TULSA PRESERVATION COMMISSION

STAFF REPORT

HP-0341-2022

PROPERTY ADDRESS: 1701 SOUTH NEWPORT AVENUE

Figure 7. Installation of Windows - Plan.

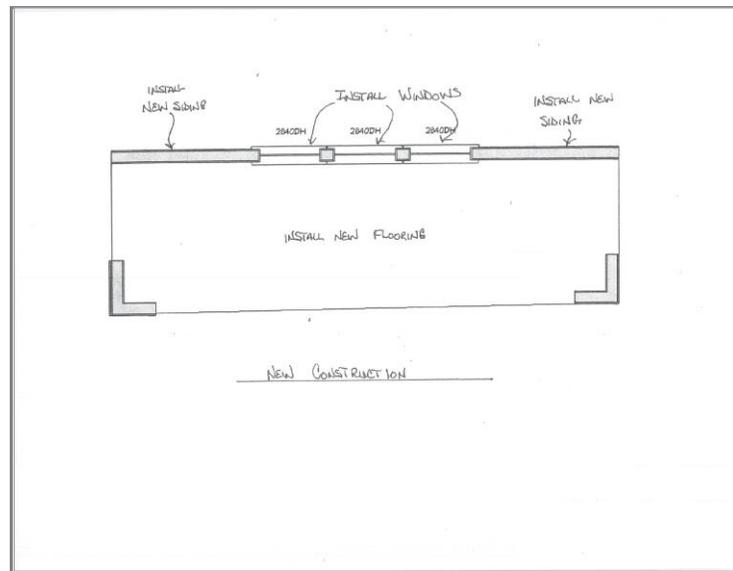
During the review by the Historic Preservation Permit Subcommittee on March 15, the documentation of the conditions was reviewed, as was the proposal to install three windows on the west facade of the residence. The installation of the windows would be centered on the space created by the removal of the windows from the area under review (Figures 7 - 8). The application has been forwarded with a recommendation for approval with the conditions that the present height of the sill in the area under review be retained and that the new floor be constructed with tongue-and-groove boards with a width of four inches (0'-4").

Figure 8. Installation of Windows - West Elevation.

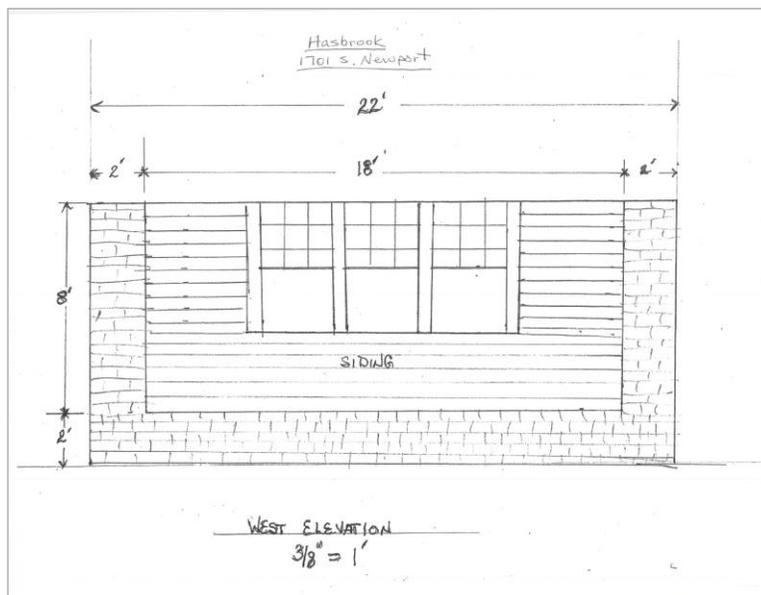
During the review by the Historic Preservation Permit Subcommittee on February 15, discussion focused on the installation of the windows on the west facade and the removal of the masonry to reveal the porch. An elevation of the west facade was requested, and the application was forwarded with a recommendation for approval. Two proposals for the installation of the windows, including an elevation, were submitted for review by the Tulsa Preservation Commission during its Regular Meeting on February 22.
